Permit of Authorization to Construct an On-Site Sewage Facility Permit Valid For One Year From Date Issued

Permit Number: 118031

RE- SEPTIC DESIGN
2142 SIERRA MADRE
ENSENADA SHORES AT CANYON LAKE, UNIT 4, LOT 78
CANYON LAKE, TX 78133
KAMP RESIDENCE

Subject:
 RE: 2142 SIERRA MADRE - KAMP #118031

TYPICAL PUMP TANK CONFIGURATION 610 GAL POLYPURE PUMP TANK

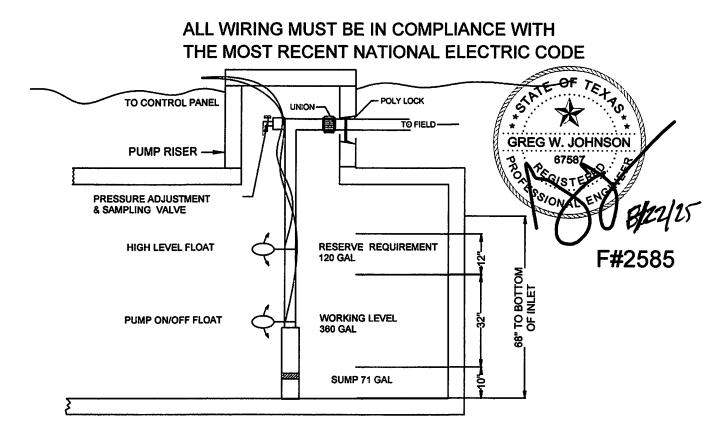
REVISED

9:23 am, Aug 27, 2025

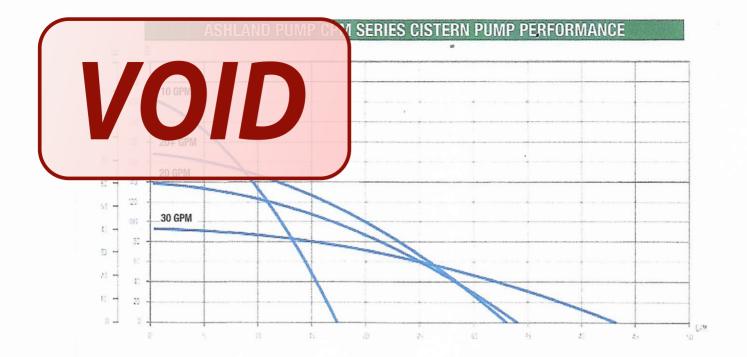
REVISED. THX, GREG

The permit file has been updated.
